Application for Approval of Details Reserved by Condition Pursuant to Planning Permission Reference: 192928. Construction of the South Wokingham Distributor Road ('SWDR') at Land South of Wokingham, East of Finchampstead Road and West of Waterloo Road, Wokingham

**PLANNING PERMISSION 192928 (CONSTRUCTION OF THE SOUTH WOKINGHAM DISTRIBUTOR ROAD (SWDR)
BETWEEN FINCHAMPSTEAD ROAD AND WATERLOO ROAD, INCLUDING A LINK TO HEATHLANDS ROAD,
TOGETHER WITH ASSOCIATED WORKS)**

Subject: SWDR conditions of planning permission 192928

Condition 5 levels (213441)

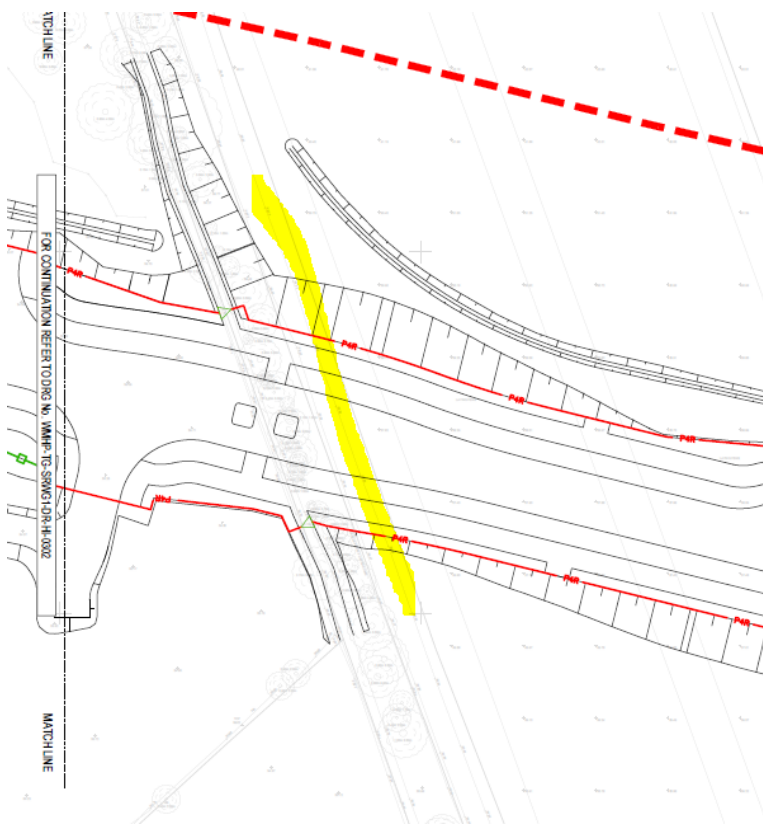
Please provide chainage drawings and longitudinal sections, as provided at the original application stage, showing existing, approved and proposed levels to allow comparison. I am aware that the consortium have raised concerns about the level of the road being increased and need to understand the scope of the issue.

and on WMHP-TG-SRWG1-DR-HI-301:

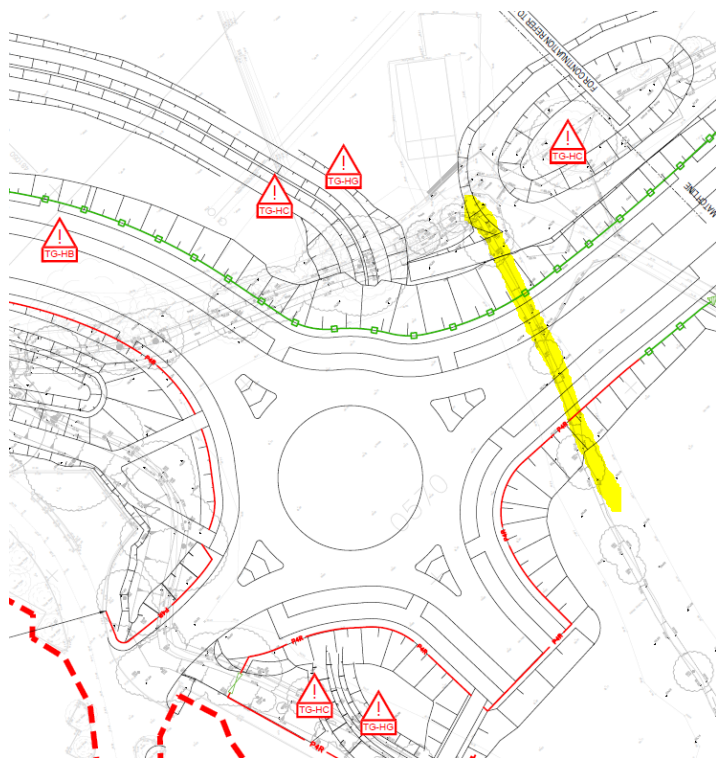
Additional mammal tunnels are required in these two locations, with reference to the fencing plans, on WMHP-TG-SRWG1-DR-HI-0303 (highlighted yellow):

Condition 11 AMS (213554)

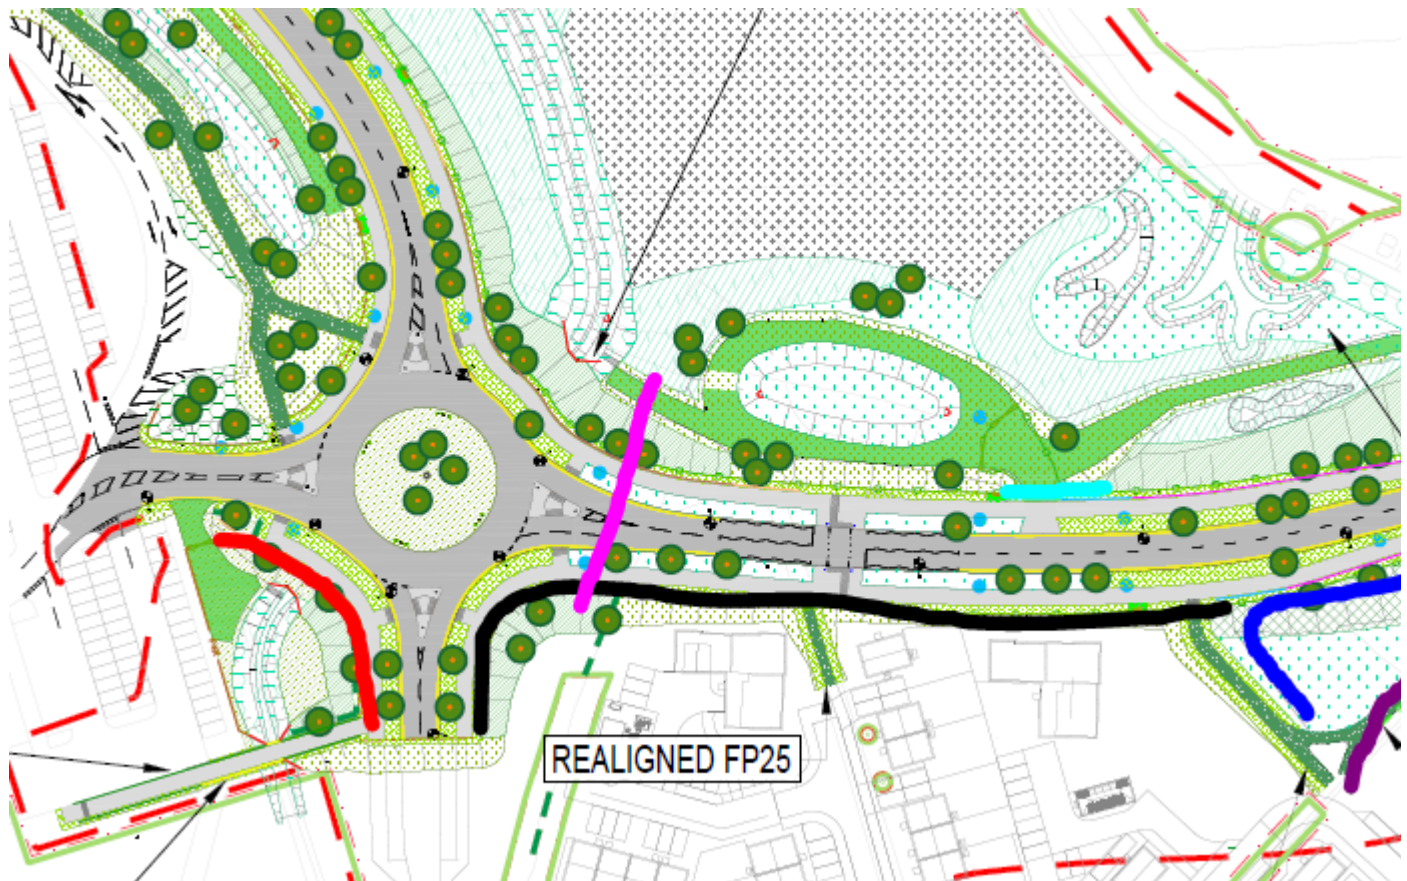
A revised AIA has been submitted but not an AMS which will need to be submitted to comply with this condition.

With reference to the WMHP-TG-SRWG1-DR-LS plans:

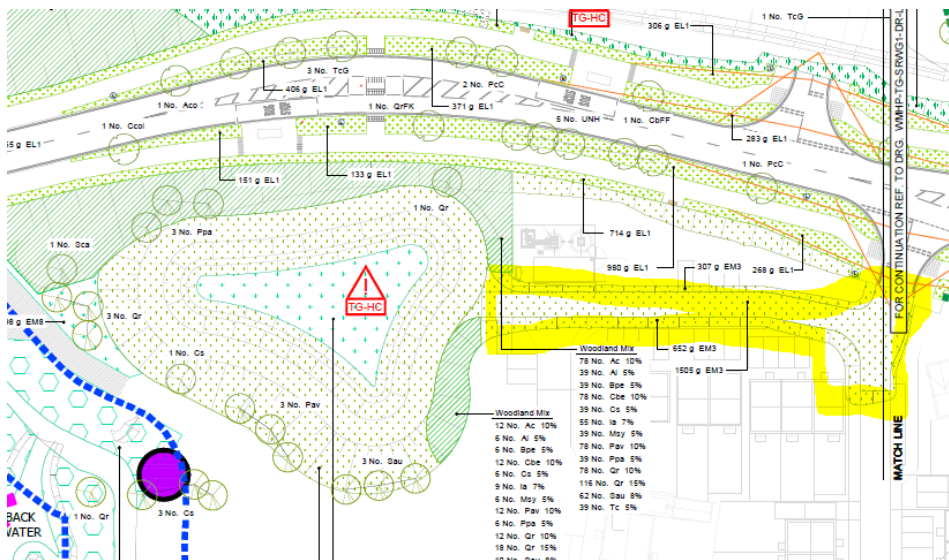
3002 P04 – The access path to the attenuation basin south of the SWDR is shown as being wildflower mix, which will not be the case in the long-term. The treatment of this area should be revised to reflect Persimmon's proposals and avoid the need for the wildflower grassland habitat to be considered in their baseline BNG assessment.

3003 P04 – The SWDR bisects an existing footpath with hedgerows that is a bat commuting corridor. As a lighting column has to be here for the pedestrian island it is important to mitigate the lighting disturbance through the tree planting. The specified *Alnus cordata* and *Pyrus calleryana* ‘Chanticleer’ will not create a dark hop over route for bats using this route. The *Quercus*, *Tilia*, or *Ulmus* species used in the street tree palette would be more appropriate for the trees highlighted in yellow below and an addition street tree should be provided in the location indicated in red below. The replacement hedgerow planting should terminate in a *Quercus*, *Tilia*, or *Ulmus* species standard (in the locations shown by pink dots) to further reinforce a safer at height flight route.

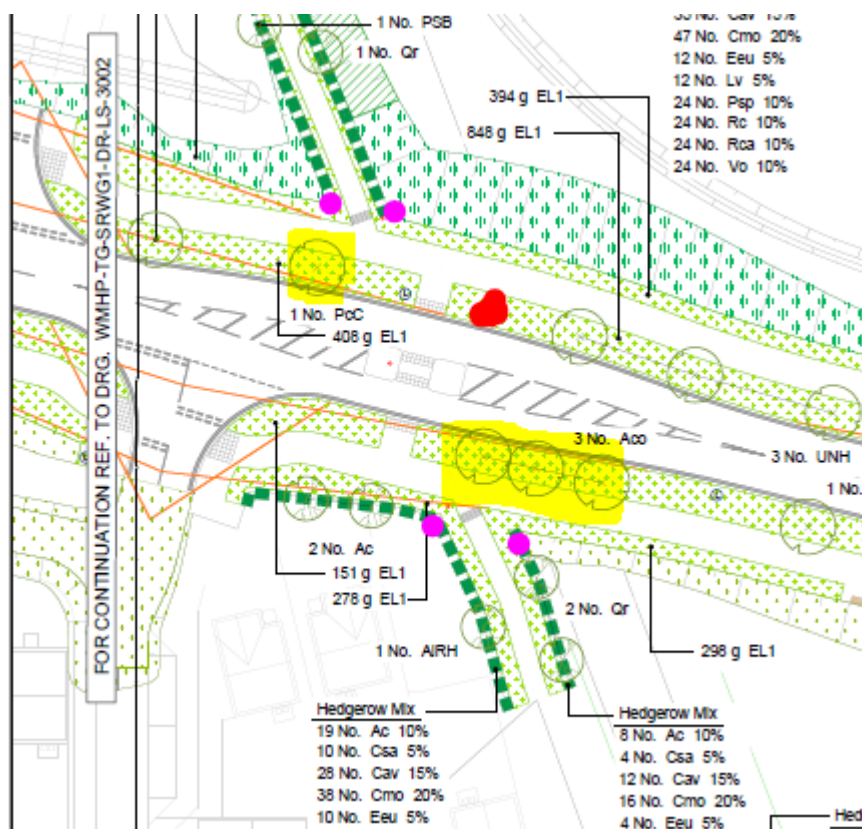
3008 P03 and 3009 P03 – The Holme Park SANG attenuation basin is designed with a flat base with the exception of fairly straight low flow channels and a few ponds. This is not the best design to promote a wetland grassland mix and the ecologist has consistently requested that the low flow channel be made more convoluted and the base of the basin be rougher in topology so as to provide a more complex and intimate variation in grassland wetness at the base of the basin. This would not conflict with the attenuation function during periods of heavy rain and would make the wetland habitat more viable by making more use of the water from lower rainfall events. The landscaping of the base of the basin should be revised to make it better for biodiversity.
